RHODE ISLAND CONTRACT NO.2017-CB-062

Central RI Bridges-Group 12

NOTICE TO PROSPECTIVE BIDDERS

ADDENDUM NO. 2 Prospective bidders and all concerned are hereby notified of the following changes in the Plans, Specifications, Proposal and Distribution of Quantities for this contract. These changes shall be incorporated in the Plans, Specifications, Proposal and Distribution of Quantities, and shall become an integral part of the Contract Documents.

1. Floorbeam "H" Repair (Natick Bridge No. 26)

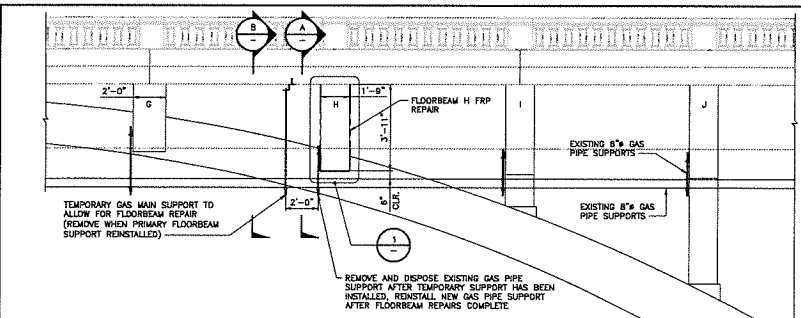
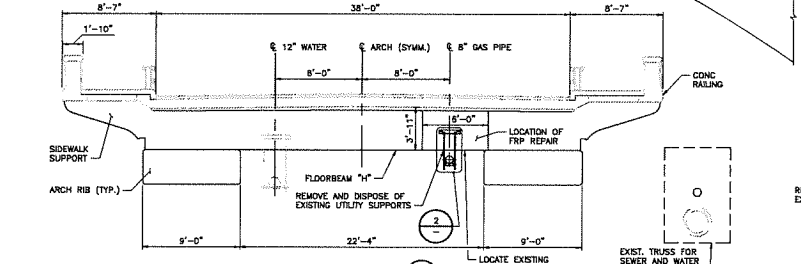
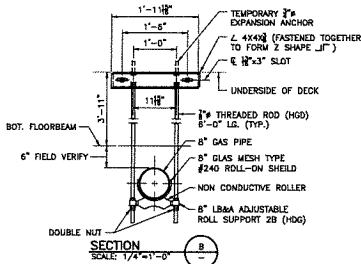
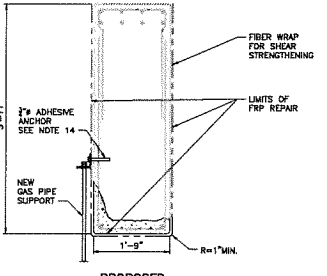
Delete Sheet 20 in its entirety and replace it with revised Sheet 20 (R-1) attached to this Addendum No. 2. The sheet has been revised.
